Service Bulletin

Bulletin No.: 22-NA-022

Subject: Diagnostic Tip for LM2 Diesel with a Rear Main Oil Leak with or without DTC P06DD set

5786655

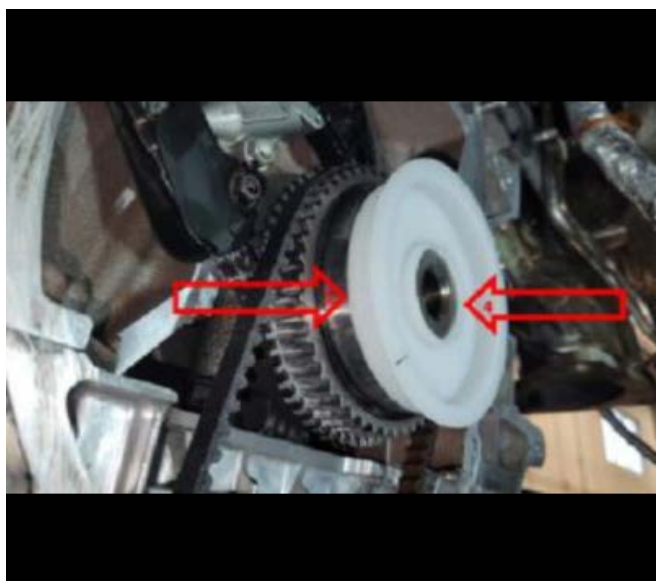
Note: The inner piece is an installation tool designed to be a substitute for the EN52466-2 installation tool. It fits over the bevel on the end of the crankshaft to facilitate installation. Be extremely mindful that the inner lip of the seal slides over the rear of the crankshaft without rolling or a repeat oil leak will occur. The protector/installer has a snug fit to the pilot of the crankshaft.

The picture below is shown without the cover for clarity.
